Fixing the 10GBASE-T EEE state diagrams

9/22/2009

State diagram comments

Figure 55-16b—EEE transmit state diagram

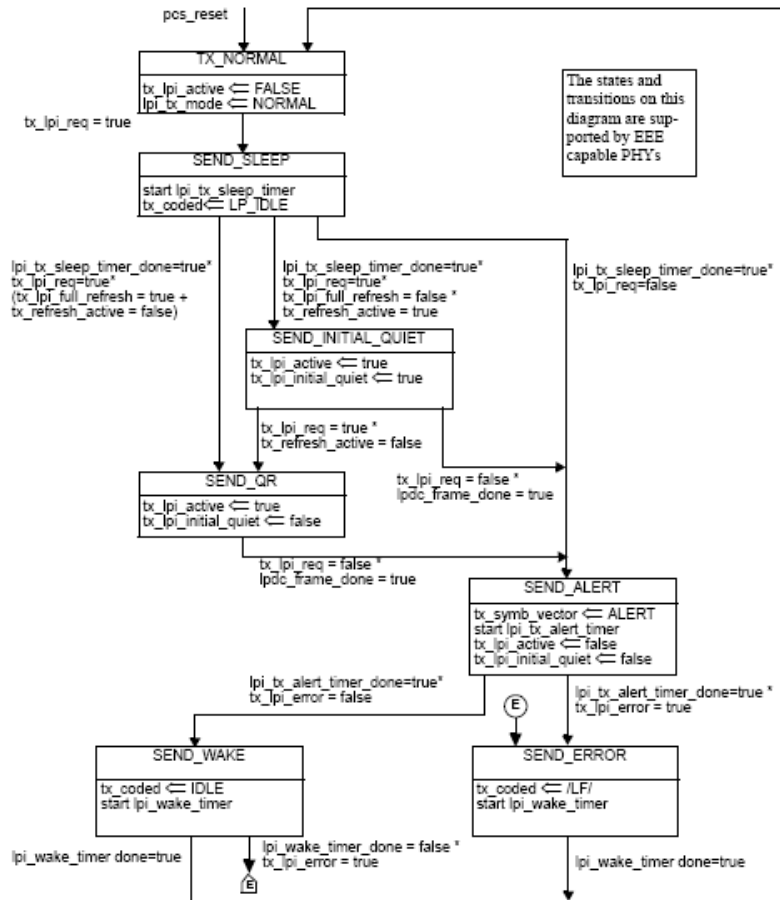
Tx_lpi_active is set false in SEND_ALERT

Tx_lpi_active==false means that lpi_tx_mode is NORMAL. From the previous text, 'the PCS... will encode codewords from the XGMII' This does not match the state diagram which has tx_coded assignments

Figure 55-15a—PCS 64B/65B Transmit state diagram part b)

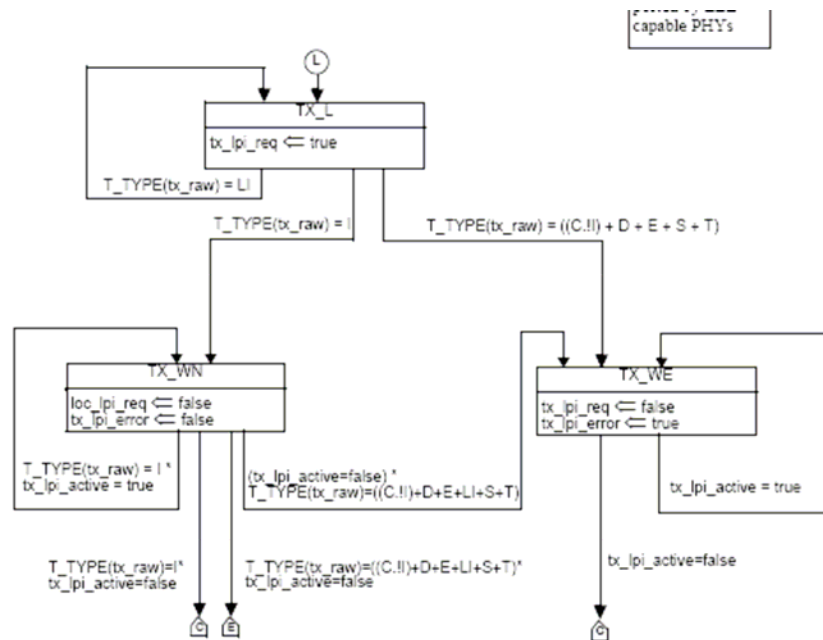
The new LPI 64B/65B Tx states do not control tx_coded . tx_coded is handled in a different state machine (55-16b) during Wake.

It is desirable to make all tx_coded assignments in 55-15 and 55-15a (a single state machine). Part of comment #380.

Figure 55-15—PCS 64B/65B Transmit state diagram part a)

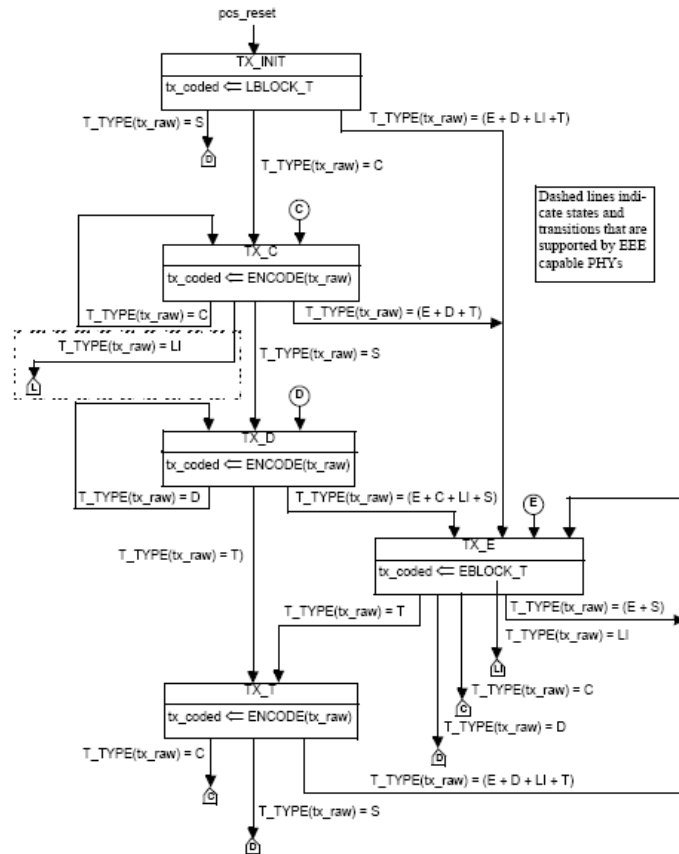
Comments #142, #143

Problem:

No transition from TX_T to TX_L

Figure 55-16b—EEE transmit state diagram

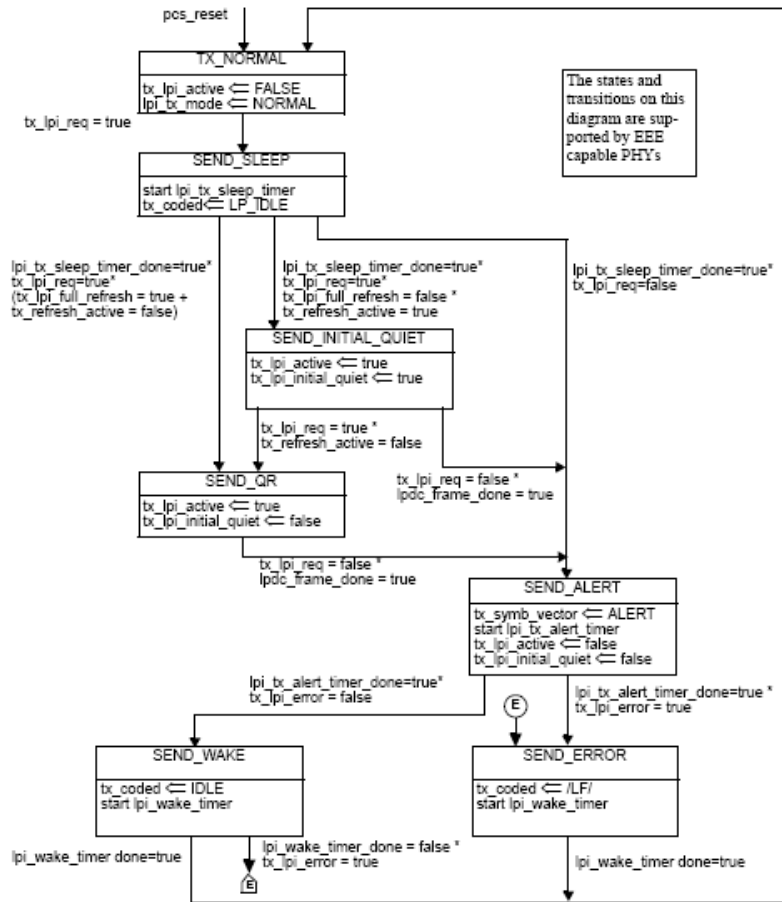
- tx_symb_vector is used in SEND_ALERT but not set anywhere else

- SEND_WAKE transitions into SEND_ERROR

Both states start lpi_wake_timer

Therefore 9 blocks of LF will be sent if any wake symbol is decoded incorrectly; it could result in 8 Wake Idles, followed by 9 LF blocks if an error is detected in the last block.

Is this desired behaviour?

Figure 55-16b—EEE transmit state diagram

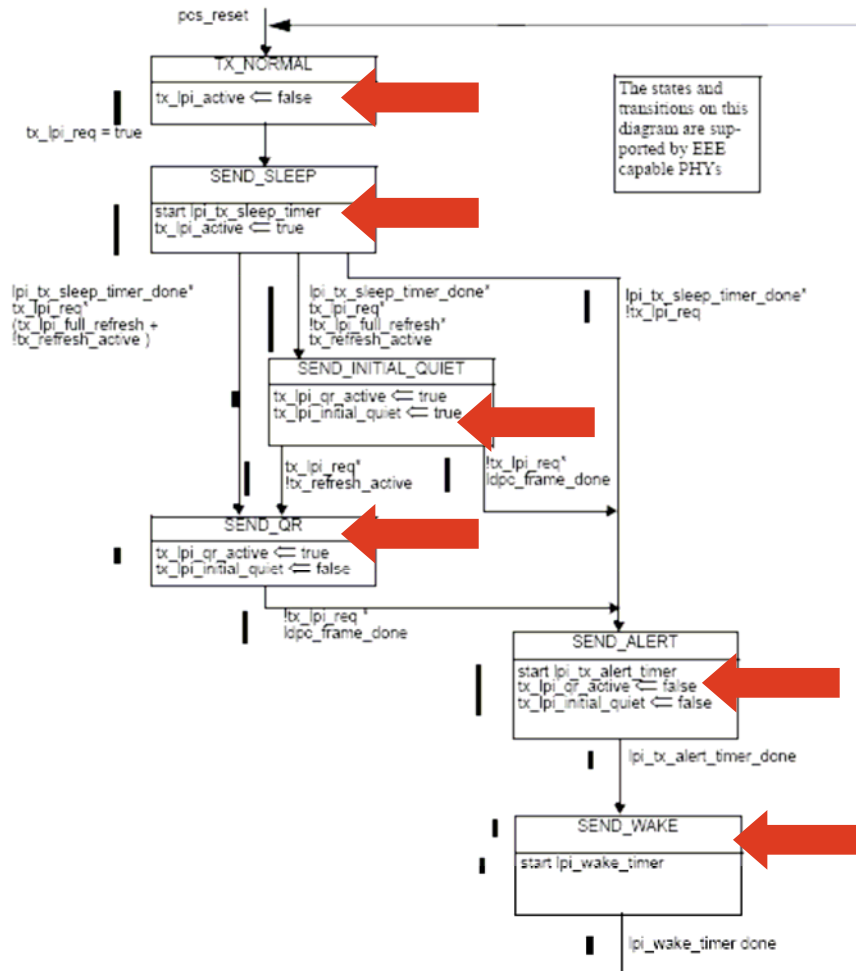
- Added tx_lpi_qr_active variable
- Fixed tx_lpi_active assignments
- Removed tx_coded assignments
- Removed tx_symb_vector <= ALERT
 - Ambiguous: tx_symb_vector is not set anywhere else in this state machine so it is not clear when tx_symb_vector is reset
 - Use lpi_tx_mode instead

Figure 55-15a—PCS 64B/65B Transmit state diagram part b)

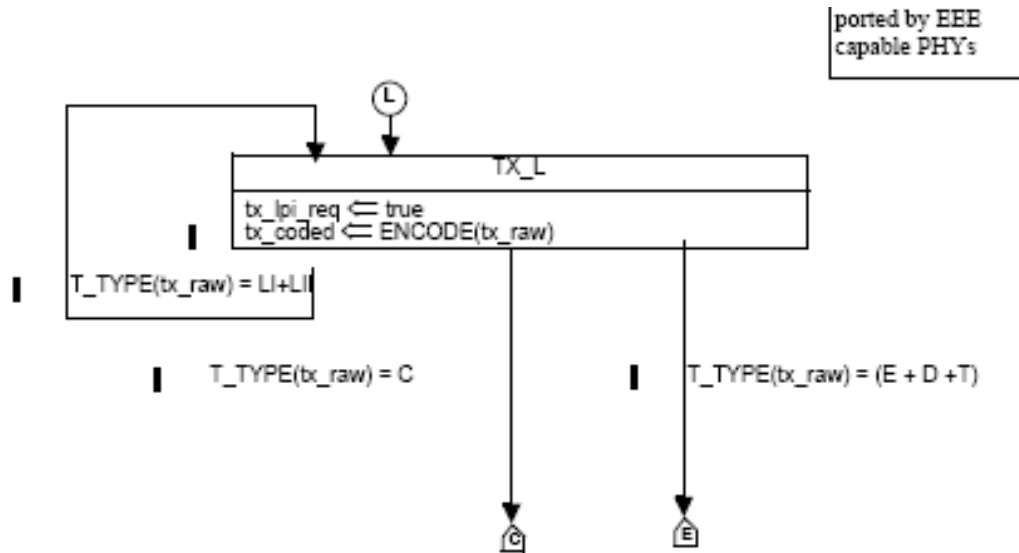
If comment #377 is accepted: Tx fixes : change 64B/65B Tx state diagram 55-15a

- Pass codewords on XGMII through PCS datapath
- Does not force values onto tx_coded through state machine
- Removes wake states and simplifies state machine

If comment #377 is accepted: Tx fixes : change 64B/65B Tx state diagram 55-15

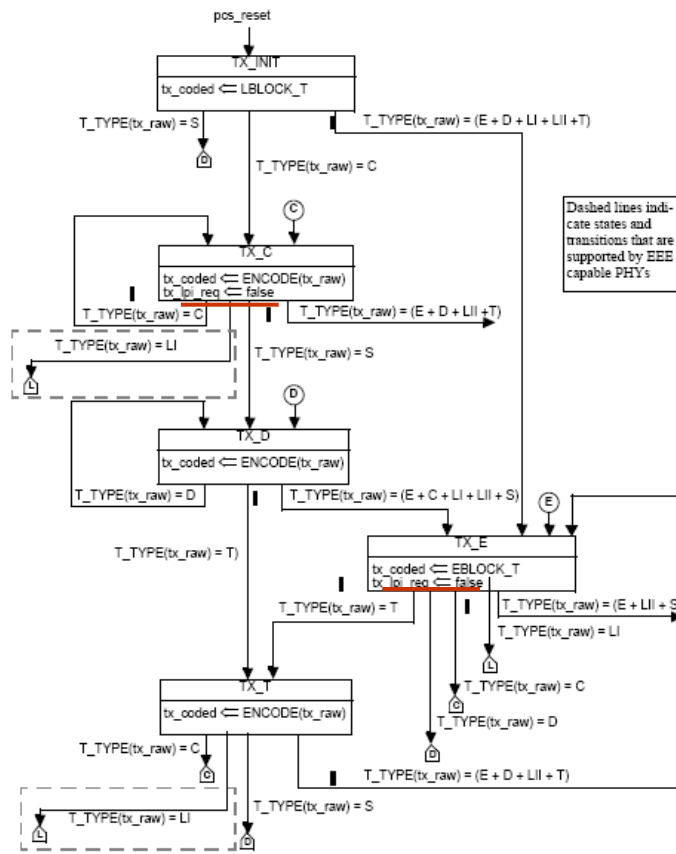
- Reset tx_lpi_req in TX_C and TX_E
- Make it clear that these assignments are only required for EEE capable PHYs [box the assignments?]

Figure 55-15a—PCS 64B/65B Transmit state diagram part b)

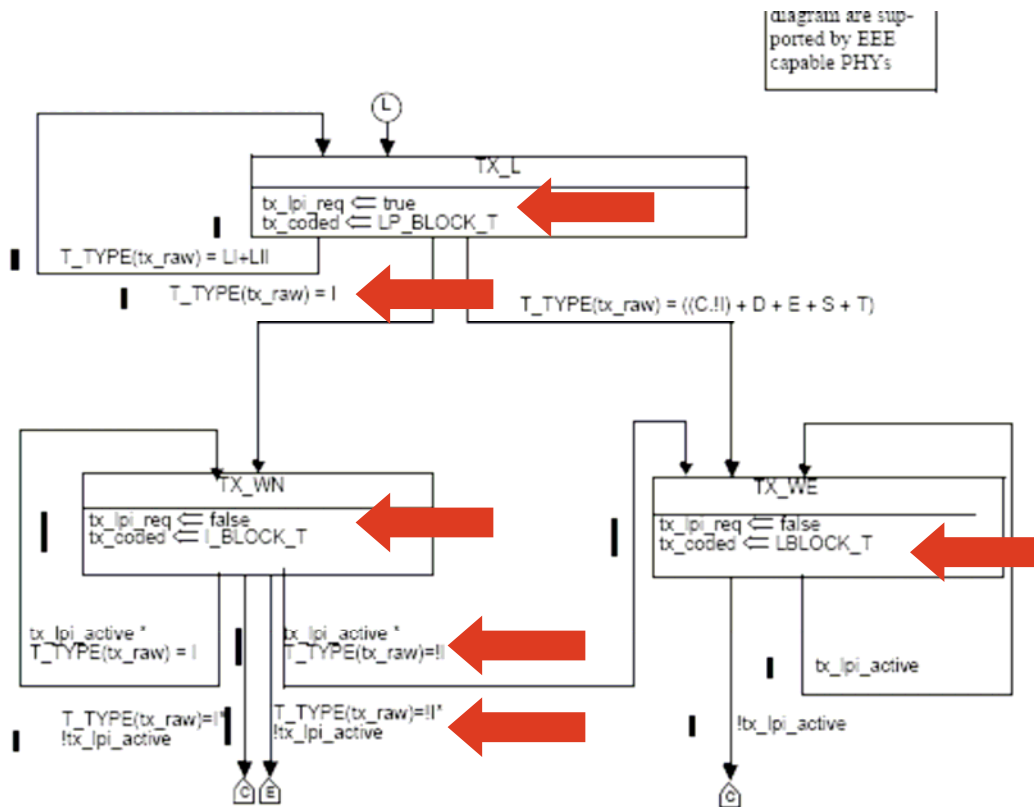
- Added tx_coded assignments to these states
- Corrected block names / functions
- Added LII transitions
- Fixed tx_lpi_active on TX_WN to TX_WE branch

Figure 55-16—PC 64B/65B Receive state diagram, part a)

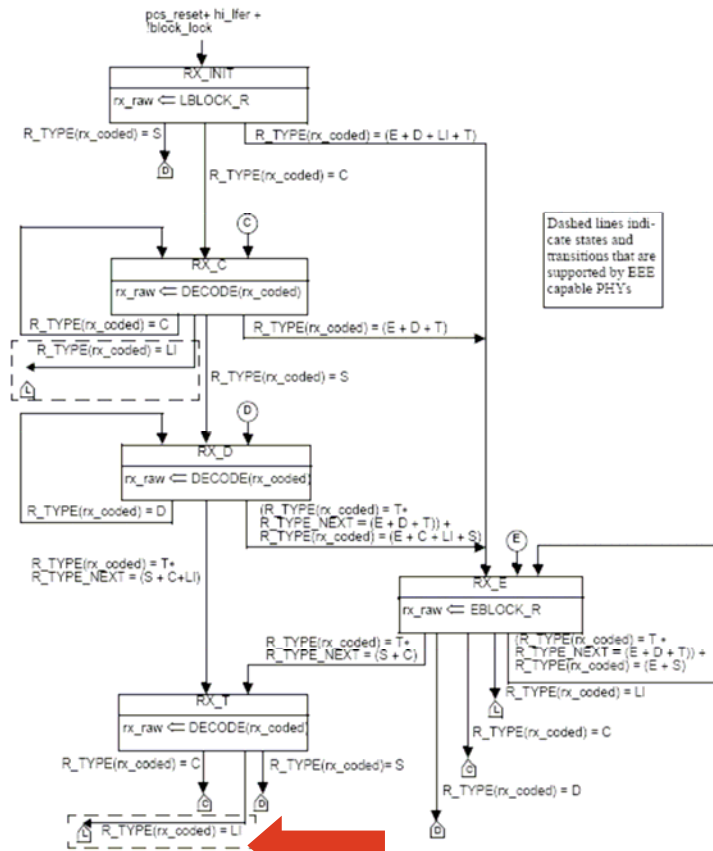
- Added LI transition to RX_T state
- Analogous transition added to tx side

Figure 55-16a—PCS 64B/65B Receive state diagram, part b)

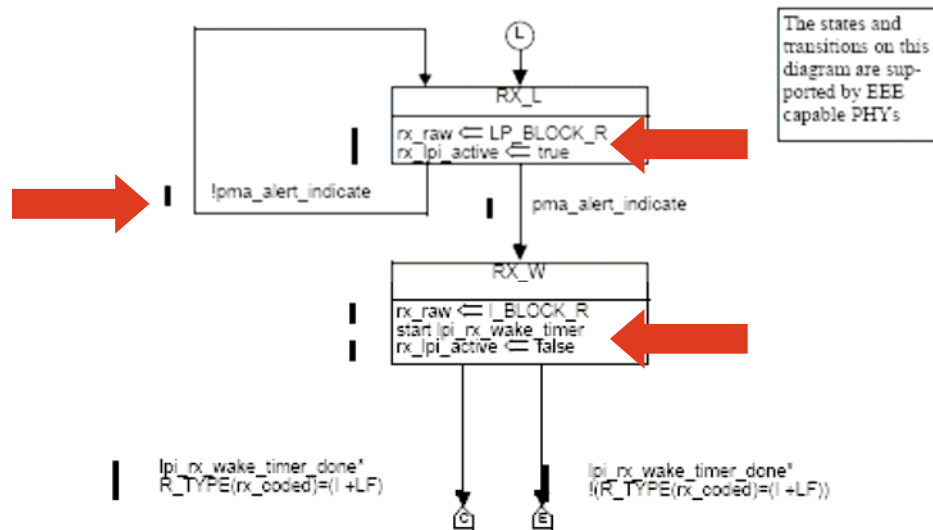
- Delete PMA Rx state diagram
 - Pass pma_alert_indicate to PCS
 - Delete references to rx_lpi_req
 - Simplifies state diagrams without changing functionality
- Fix rx_raw assignments
 - Incorrect names were used
- **Functionally exactly the same as draft 2.0**
